ENVIRONMENTAL IMPROVEMENT (REMEDIATION) WORKS AT THE FORMER GASHOLDER STATION, HARWOOD ROAD, LITTLEHAMPTON BN17 7AU

Following the receipt of comments from Environmental Health and the Environment Agency relating to *Condition 3 – Verification Report*, please find below Worley Consulting responses.

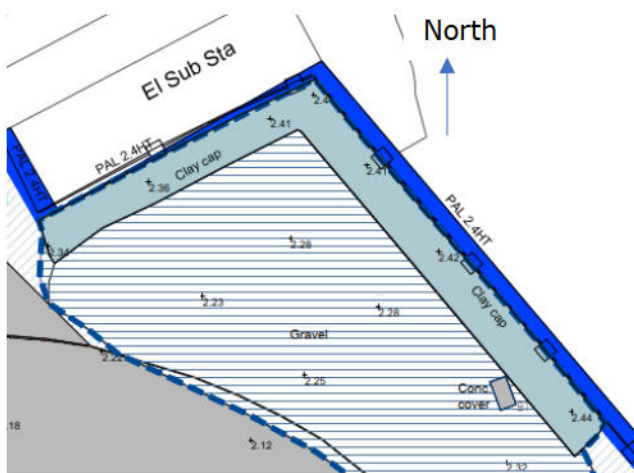
Clarification is required regarding the clay cut off wall. The approved remediation strategy specifies installation along the north and west boundaries of Area C, whereas the Verification Report records installation along the north and east boundaries. This may be clerical error, but confirmation is required as to which is correct.

The clay cut-off wall was installed along the northern extent of Area C, extending along both the northwestern and northeastern boundaries, as shown in the verification drawing below. The wall was installed in accordance with the approved design and remediation strategy. The apparent discrepancy arises from differences in the description of the wall alignment rather than any variation from the approved design. The verification report correctly reflects the as-built installation, and no deviation from the approved remediation measures occurred.
